1997 - 1998, 2000 Corvette: Service Bulletin: Electronic Steering Column Lock May Refuse to Operate - DIC Service Message Displayed

Number: 01-02-35-008

Subject: Electronic Steering Column Lock May Refuse to Operate - DIC Service Message Displayed (Update Column Lock Wiring, Install Revised Relay and/or Replace Electronic Column Lock)

Model Year: 1997-1998, 2000 Chevrolet Corvette Built Between the Following VIN Breakpoints:

ECL Disconnect: 1997, 1998 and 2000 Models with Automatic Transmission (Domestic)

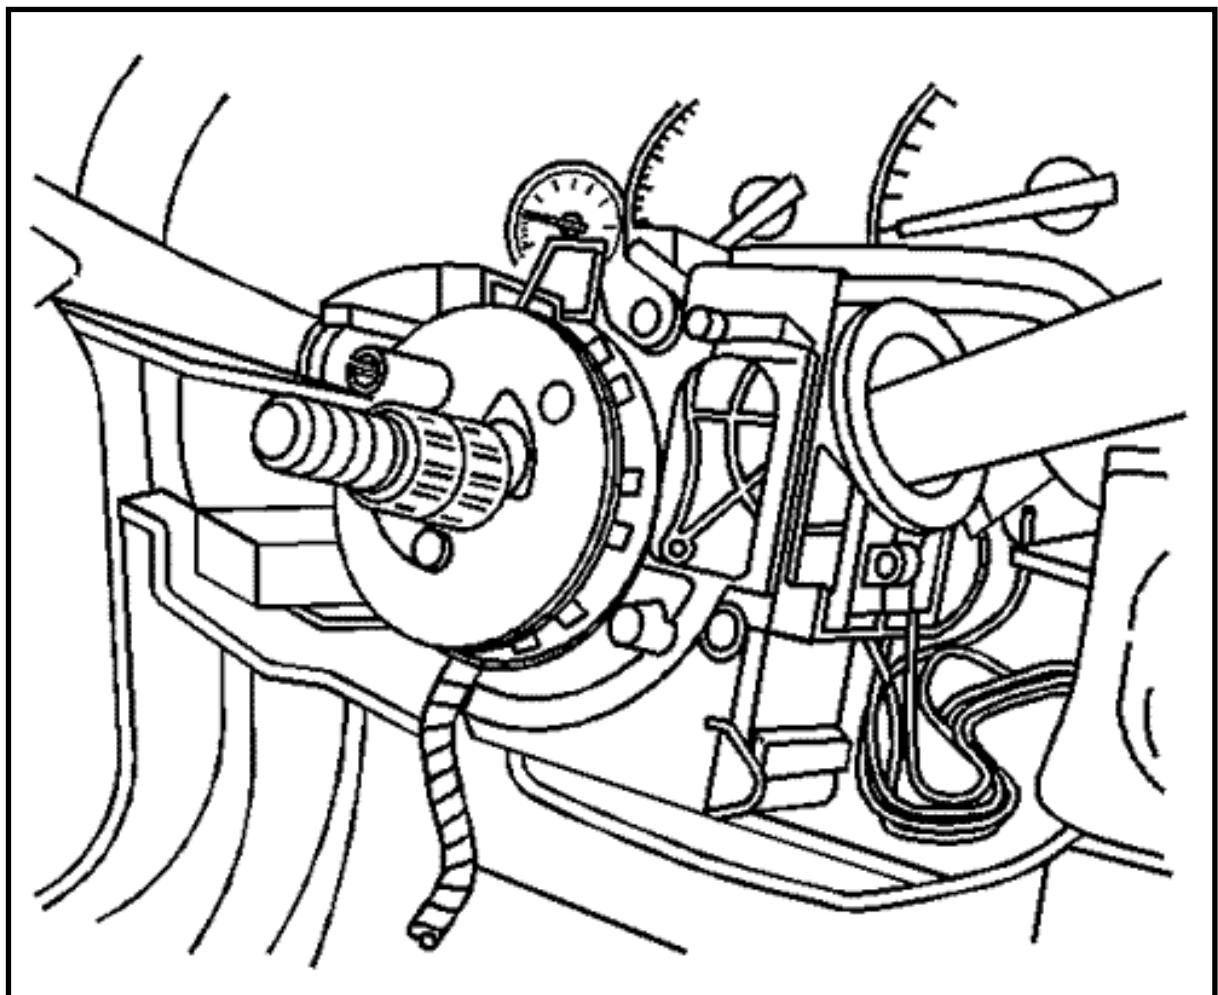
1. Disconnect the negative battery cable.
2. Disable the SIR module. Refer to Disabling the SIR System in the SIR sub-section of the Service Manual.
3. Remove the driver's side SIR module from the steering wheel.
4. Remove and discard the steering wheel set nut.
5. Using J 1859-A and J 42120, remove the steering wheel.
6. Remove the tilt steering lever.
7. Remove the combination trunk release and fog light switch.

8. Remove the driver's side knee bolster trim retaining screws and panel. Pull back the console trim panel away from the I/P and disengage the knee bolster trim panel.
9. Remove the wiper control stalk.
10. Remove the lower and upper steering column shrouds. If the vehicle is equipped with power telescoping feature, disconnect the telescoping switch.
11. Remove the snap ring and SIR coil from the steering column.

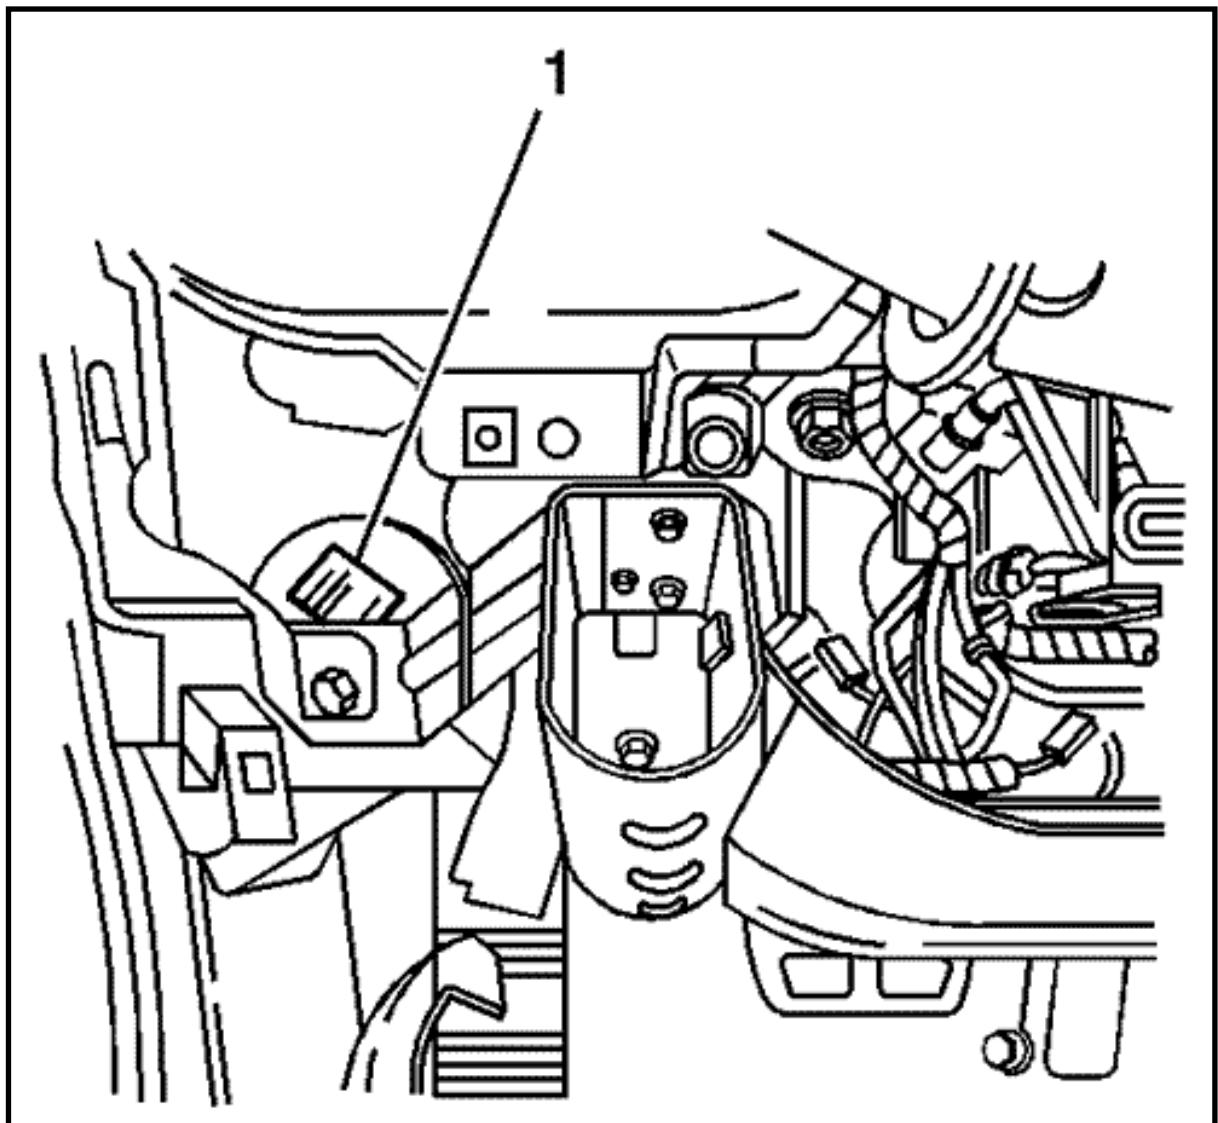
12. Remove and discard the Steering Column Lock/Cam Orientation plate

using the J 38364.

13. Install the included Cam Orientation Plate and secure with a new locking ring, using J 42137 and J 38364 as shown.
14. Install the SIR coil and secure with snap ring.
15. Disconnect the connector from the ECL (located on the right lower side of the steering column) to the I/P main harness.

16. Route the new jumper wire and relay harness over the knee bolster (styrofoam and metal construction). The new relay (1) must be mounted to the left I/P brace with a zip tie as shown.

17. Install the new relay and jumper harness. Plug one end of the jumper harness into the connector on the I/P harness side. Plug the other end into the connector on the ECL side. The connectors on the jumper are specific and cannot be connected incorrectly. The connector becomes J165/P165.
18. Install the lower and upper steering column shrouds.
19. Install the wiper control stalk.
20. Install the tilt steering lever.
21. Install the steering wheel to the steering column.
22. Install a new steering wheel set nut, P/N 26056108. **Tighten**

Tighten the new steering wheel set nut to 41 N·m(30 lb ft).

ECL Upgrade: 1997,1998 and 2000 Models with Manual Transmission or Export Vehicles

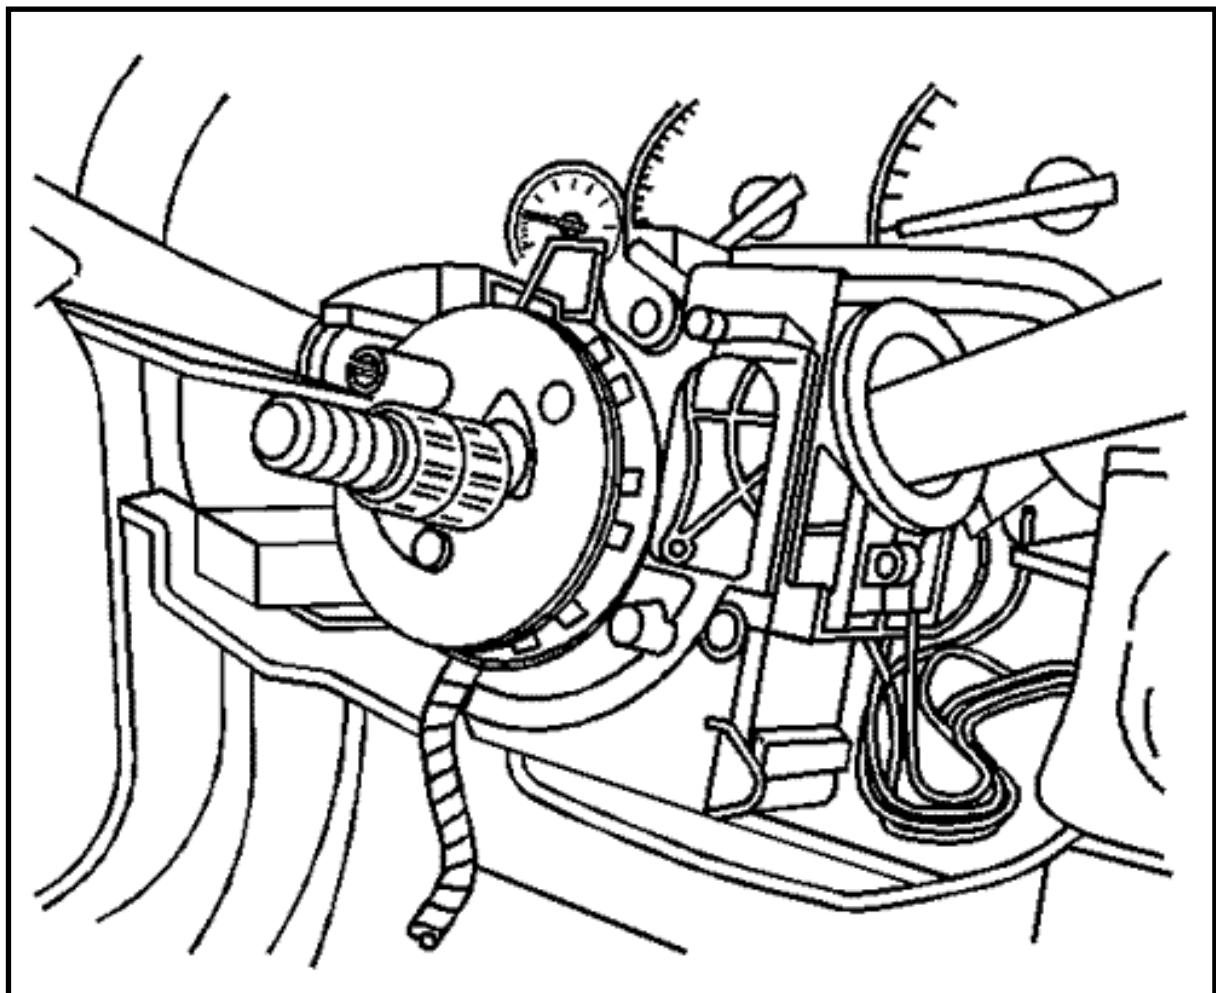
In order to complete the repairs for the vehicles referenced above, you must order P/N 26056108 Nut, Steering Wheel and P/N 26050960 Lock, Strg Whl Theft Dtrnt.

1. Disconnect the negative battery cable.
2. Disable the SIR module. Refer to Disabling the SIR System in the SIR sub-section in the Service Manual.
3. Remove the driver's side SIR module from the steering wheel.
4. Remove and discard the steering wheel set nut.
5. Using J 1859-A and J 42120, remove the steering wheel.
6. Remove the tilt steering lever.
7. Remove the combination trunk release and fog light switch.

FIGURE 1997 and 1998 (early) Manual (U.S. & Canada and All Export (Manual & Auto)(c)

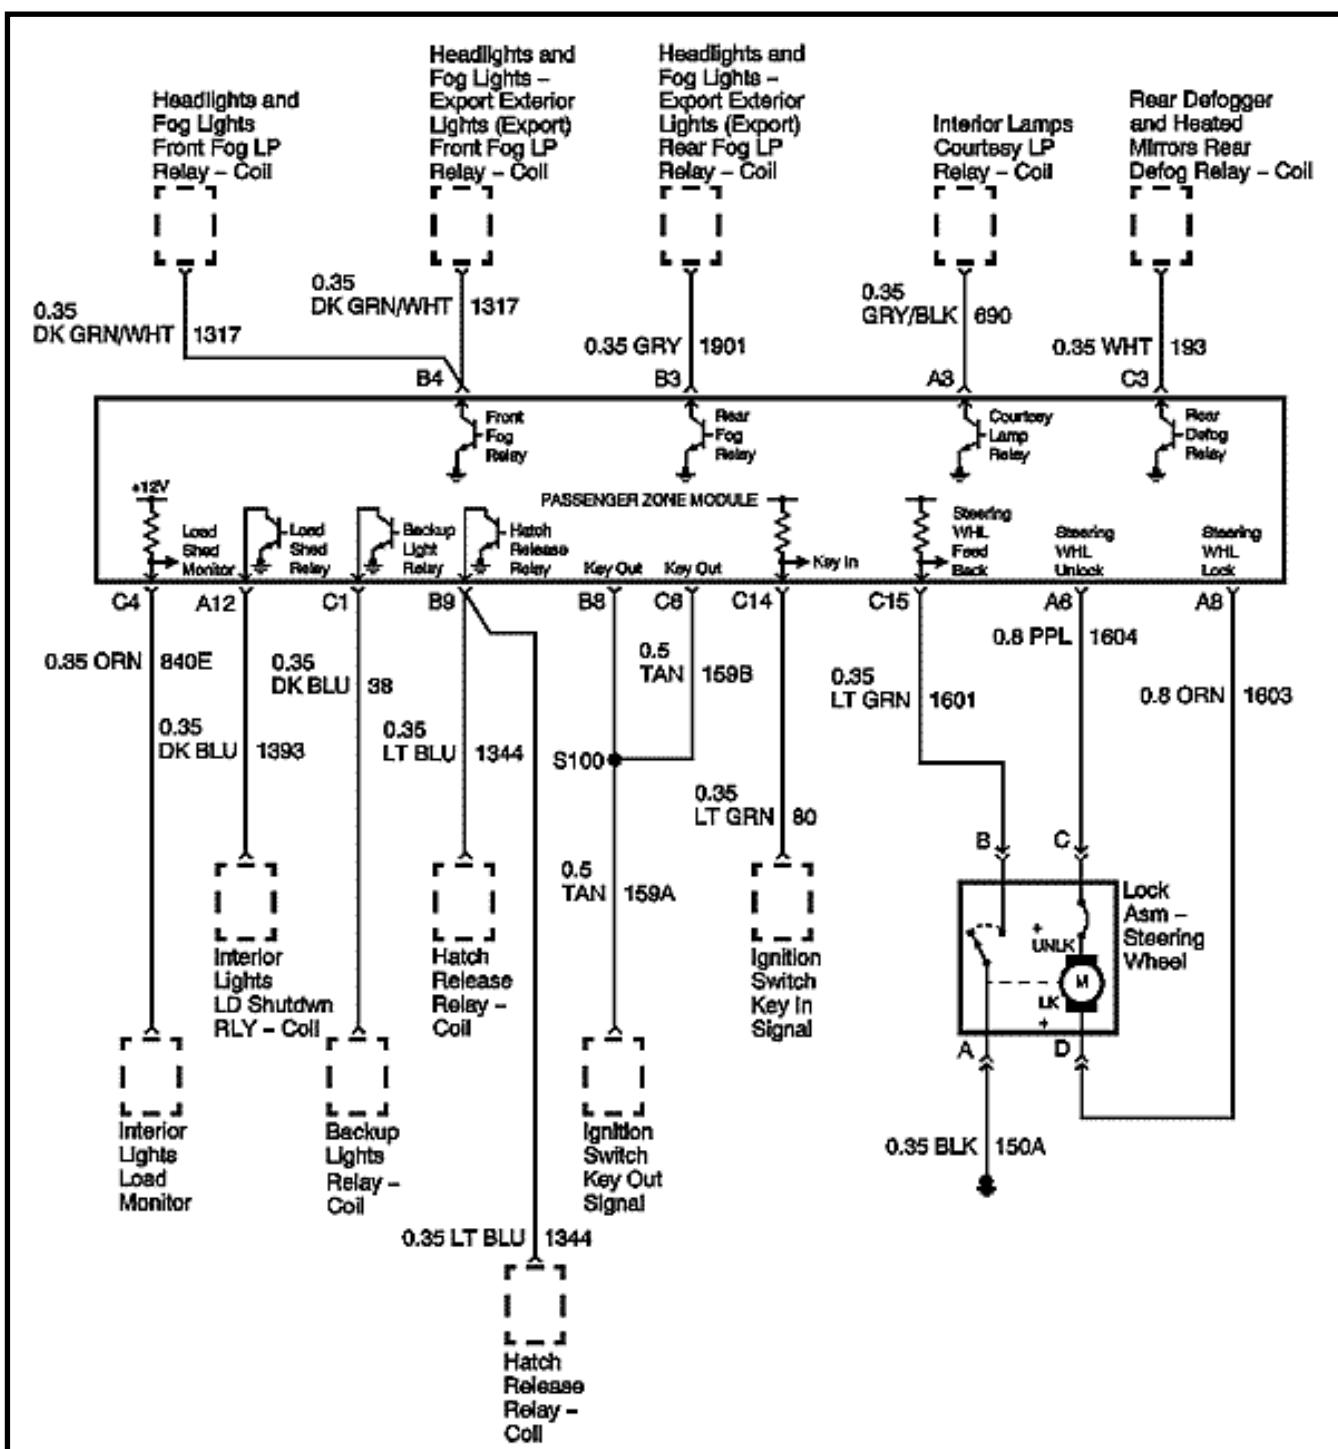
- **In order to complete the wiring upgrades listed in the section, you will need to order P/N 88952428, Wire Kit, Strg Wheel Theft Dtrnt.**
- **You may use the included schematics to aid in verifying the installation of the new relay and jumper wire.**
